Development Assessment

Subject: Item 3.3 - MOD2019/0641 - 1A Queenscliff Road, Queenscliff - Modification of Development Consent DA2015/1267 granted for alterations and additions to a residential flat building to include internal and external changes and a turntable in the basement car park.

Record Number: 2020/212534

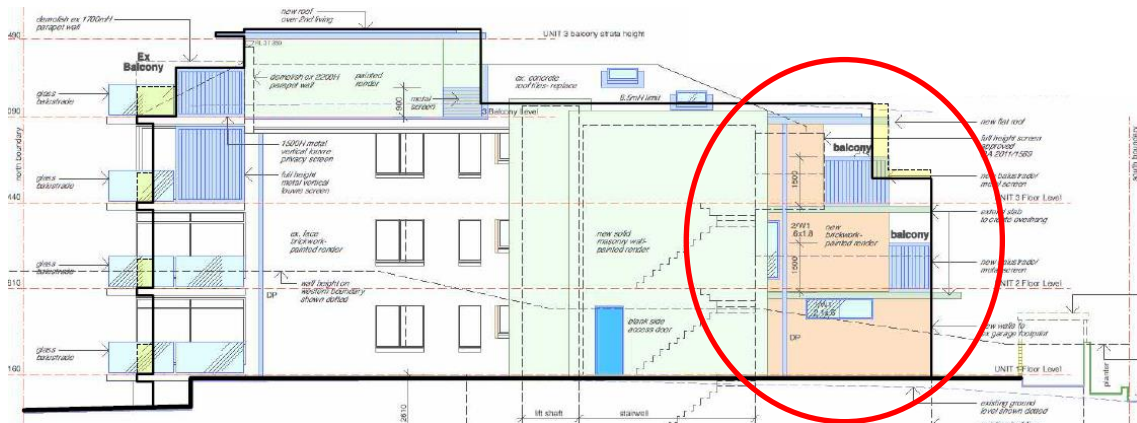
In order to clarify, in removing the pitched roof the proposal would not enable views of the horizon because of the parapet which extends above the side walls of the building (as shown in black outline in the figures below). Rather, it was meant to convey that the proposal would provide greater 'distance' and skyline views to the east (i.e. towards the horizon but not of the horizon).

The photograph below illustrates the effect of the proposal on views from the Living Room window of Unit 13 although it should be noted that this is approximate due to difficulties scaling to a photograph (Note: Red = the approved development under DA2015/1267 while black = the proposal).

The elevation below the photograph shows the proposal (outlined in black) against the approval of DA2015/1267. The area of focus in the photograph is circled in red.

As can be seen, the extent of view loss to Unit 13 occurs at the top floor (Unit 3) within the space between the approved awning and the approved side screen as this space is now proposed to be filled.

In this respect, it is considered appropriate to classify the degree of view loss to the Living Room as moderate rather than minor (as indicated in Principal 3 on page 158).
